# 45 McLaren St

## North Sydney

Response to Council RFI

February 2024

**Pictured**  
Level 8 with increased communal open space (Amended Design)

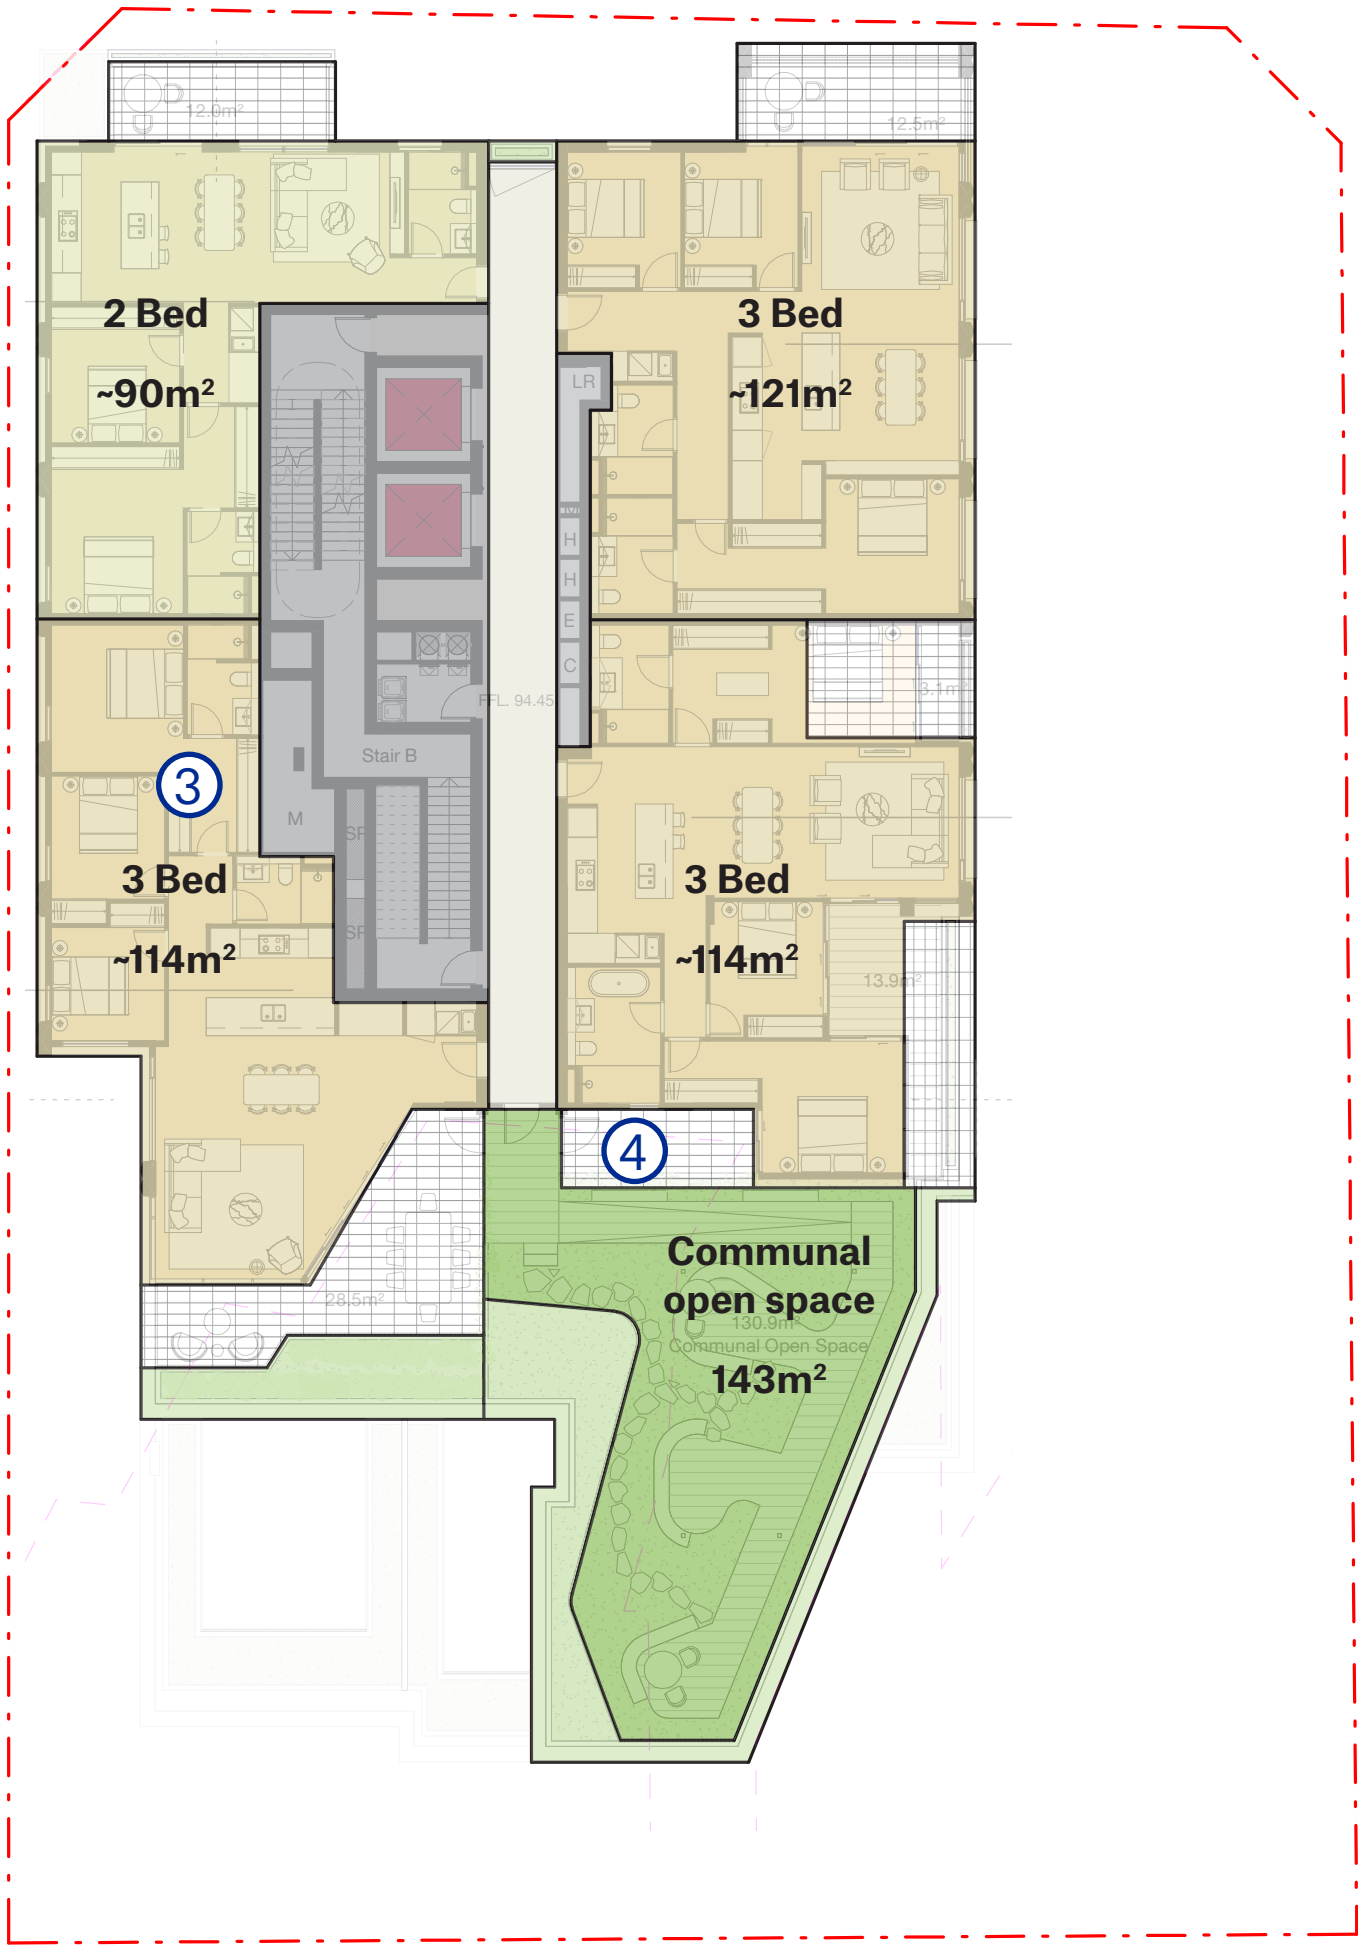
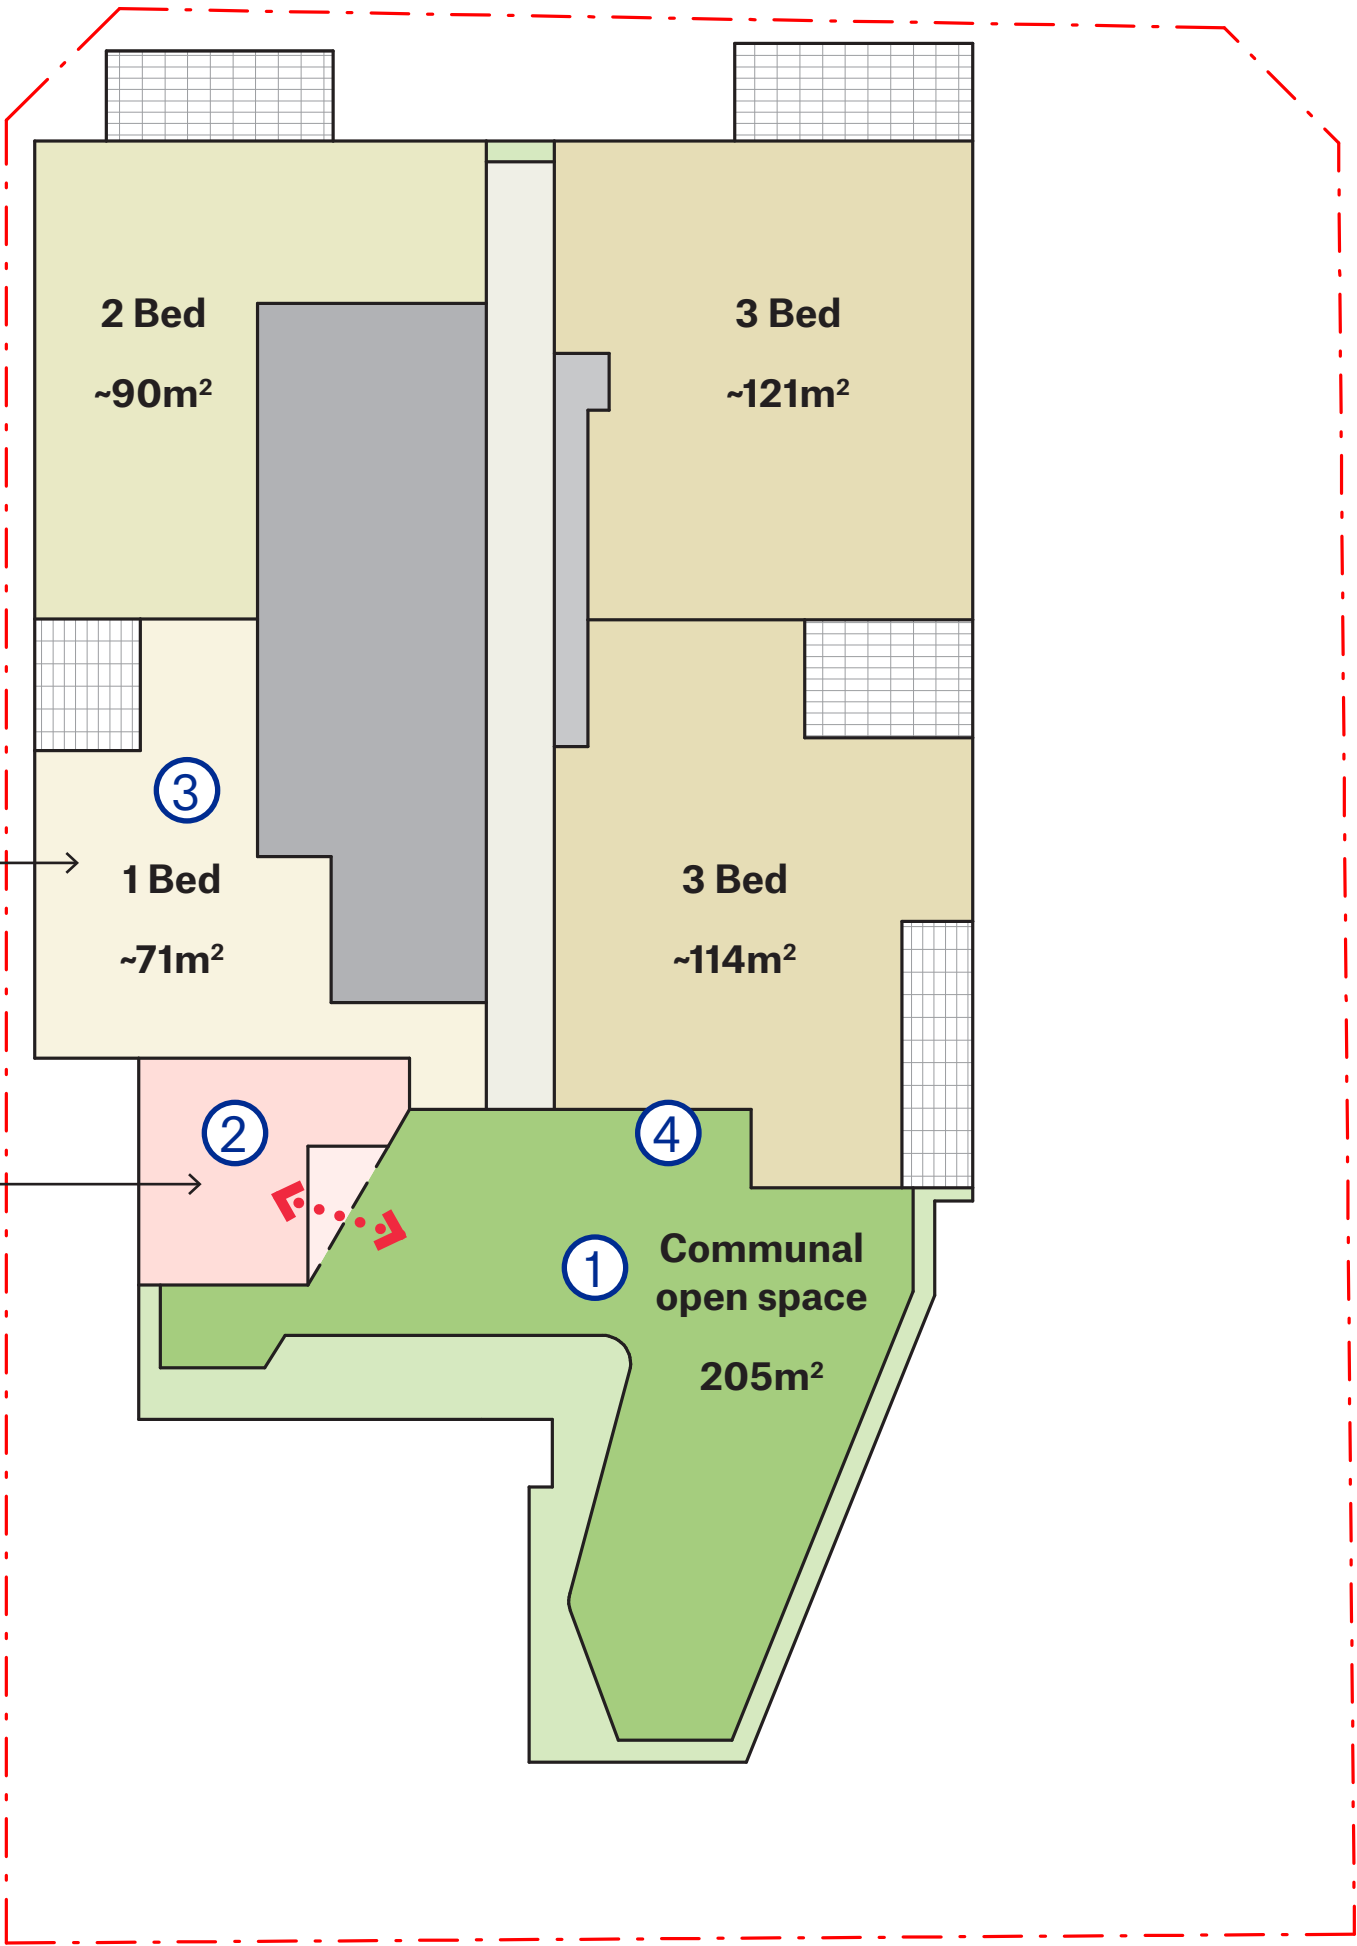
*Communal open space - The **deck proposed on level 8** is unacceptable, in terms of area and amenity offered, particularly given the reduced solar access to other areas of the proposal. The space seemed to have a poor relationship with the internal and external living areas of apartments next to the communal space. The deck should be significantly **enlarged** and **better connected to the main circulation and a genuine internal communal space**.*
